**From:** Franzone, Steve [<mailto:Steve.Franzone@fpl.com>]  
**Sent:** Monday, September 17, 2012 7:10 PM  
**To:** Comar, Manny  
**Cc:** Maher, William; Burski, Raymond  
**Subject:** DRAFT RAI Responses FPL Turkey Point 6 & 7 for eRAI 6024 Basic Geologic and Seismic Information - Part 1 of 4

**NRC RAI Letter No. PTN-RAI-LTR-041**

**SRP Section: 02.05.01 - Basic Geologic and Seismic Information**

**NRC RAI Number: 02.05.01-23 (eRAI 6024)**

**Figure 4. Fault Map of Cuba including Postulated Offshore Las Villas and Sierra de Jatibonico Faults from Reference 2**

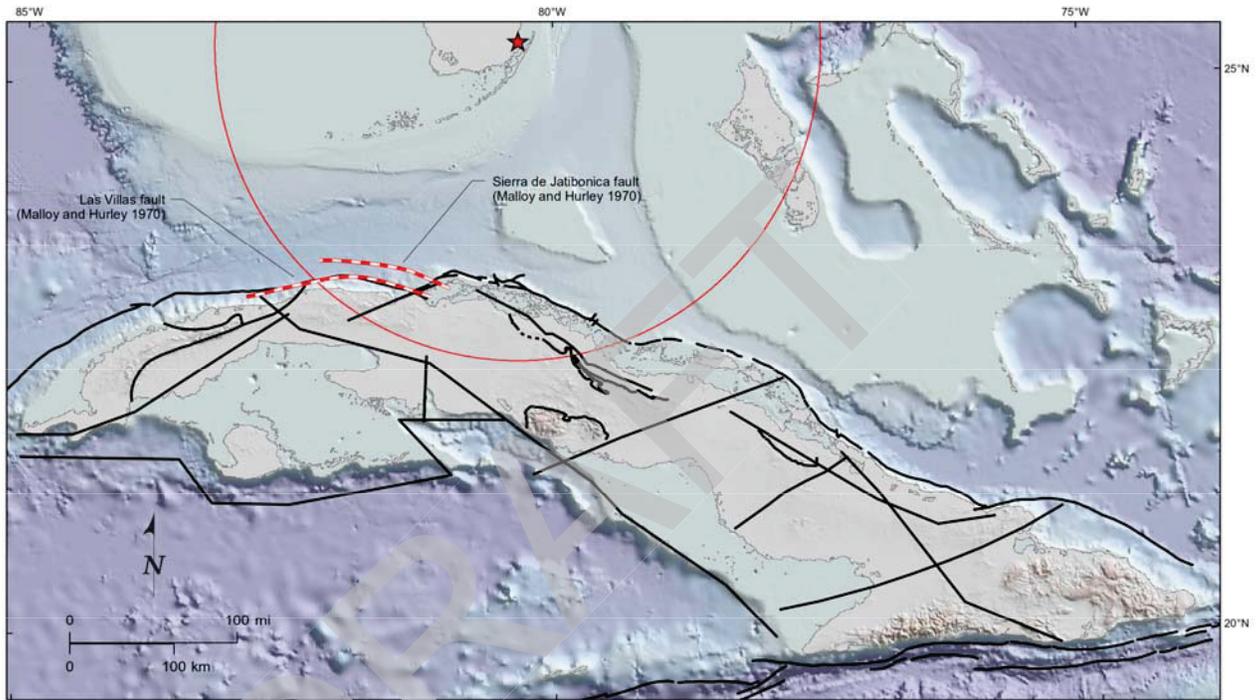
**b) In the context of the chronology of geomorphic surfaces on Cuba, clarify the distinction between erosional processes that may have recently created “young” fault-line scarps along the Las Villas fault and Quaternary tectonic fault scarps.**

Figure 4 is a map of faults in Cuba compiled for this project from various sources. This map shows Pardo’s (FSAR Subsection 2.5.1, Reference 439) depiction of the Las Villas fault and

Case and Holcombe's (FSAR Subsection 2.5.1, Reference 480) depiction of the Nortecubana fault as black lines. Additionally, this map shows Malloy and Hurley's (Reference 2) depictions of the postulated offshore Las Villas and Sierra de Jatibonico faults as red and white lines. As shown on Figure 4, Malloy and Hurley's (Reference 2) offshore Las Villas fault is roughly coincident with Case and Holcombe's (FSAR Subsection 2.5.1, Reference 480) Nortecubana fault between roughly Matanzas Bay and Havana. For this reason, it is assumed that Malloy and Hurley's (Reference 2) offshore Las Villas fault is a portion of what Case and Holcombe (FSAR Subsection 2.5.1, Reference 480) later mapped as the Nortecubana fault and that Malloy and Hurley's (Reference 2) offshore Las Villas fault is not the same structure as the Las Villas fault mapped by Pardo (FSAR Subsection 2.5.1, Reference 439), Cotilla-Rodriguez et al. (FSAR Subsection 2.5.1, Reference 494), Perez-Othon and Yarmoliuk (FSAR Subsection 2.5.1, Reference 848), Pushcharovskiy (FSAR Subsection 2.5.1, Reference 847), and others. As such, Reference 2 observations of possible bathymetric expression of the offshore Las Villas fault are assumed to be irrelevant for assessing the recency of movement on the mostly onshore Las Villas fault as defined by Pardo (FSAR Subsection 2.5.1, Reference 439) and others, but may be relevant for the Nortecubana fault.

Figure 1. Fault Map of Western Cuba Showing Earthquakes from the Project Phase 2 Earthquake Catalog

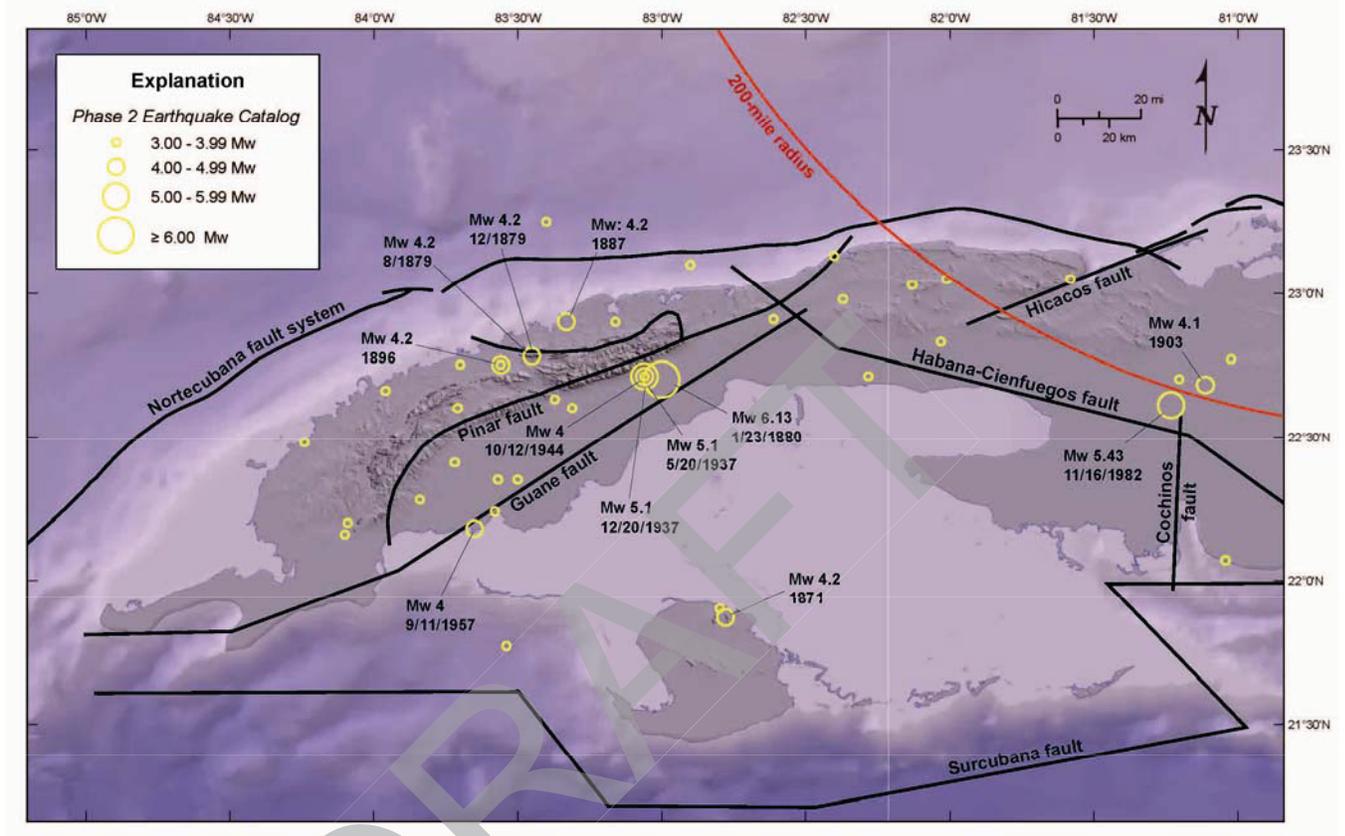
- a) Provide a thorough discussion of the Pinar fault zone including plotting seismicity, and location uncertainties, with respect to the Pinar fault.
- b) Discuss the possible sources of the January 22, 1880 M 6.0 - 6.6 San Cristobal earthquake and clarify what evidence is required to establish a connection between the 1880 earthquake and the Pinar fault. If the 1880 earthquake did not occur on the Pinar fault, please provide a detailed discussion of other faults or tectonic features that might have been responsible for the 1880 event.
- c) If the Pinar fault is not active, please discuss geological processes that might lead to preservation of the continuous, linear fault trace through map units of variable ages and lithologies.

The Pinar fault is a northeast-striking, steeply southeast-dipping fault in western Cuba (Figure 1). As mapped by Tait (2009) (FSAR Subsection 2.5.1, Reference 448) and shown in Figure 1, the Pinar fault is located, at its nearest point, approximately 205 miles (330 kilometers) from the Turkey Point Units 6 & 7 site. As mapped by Garcia et al. (2003) (FSAR Subsection 2.5.1, Reference 489), the Pinar fault is approximately 200 miles (320 kilometers) southwest of the site at its nearest point. As mapped by Cotilla-Rodríguez et al. (2007) (FSAR Subsection 2.5.1, Reference 494), the Pinar fault is approximately 225 miles (360 kilometers) southwest of the site at its nearest point. Rosencrantz (1990) (FSAR Subsection 2.5.1, Reference 529) maps a series of offshore faults along the eastern Yucatan Platform and tentatively indicates they could be the offshore southwestern extension of the Pinar fault.

The project Phase 2 earthquake catalog, which is declustered and includes earthquakes  $M_w$  3 and larger, indicates generally sparse seismicity in the vicinity of the Pinar fault (Figure 1). There does not appear to be an alignment of epicenters along the Pinar fault, but rather sparse earthquakes appear distributed throughout western Cuba both north of the fault in the Sierra del Rosario mountains and south of the fault in the Palacios Basin. A

As described in part a) of this response, the project Phase 2 earthquake catalog indicates that a  $M_w$  6.13 earthquake occurred on January 23, 1880, in western Cuba in the vicinity of the Pinar and Guane faults (Figure 1). The epicenter of this poorly located, pre-instrumental earthquake is approximately 7 miles (11 kilometers) south of the trace of the southeast-dipping Pinar fault and approximately 5 miles (8 kilometers) north of the Guane fault. As Garcia et al. (2003) (FSAR Subsection 2.5.1, Reference 489) suggest, however, locational uncertainties for historical earthquakes in Cuba could be on the order of 9 to 12 miles (15 to 20 kilometers) or more.
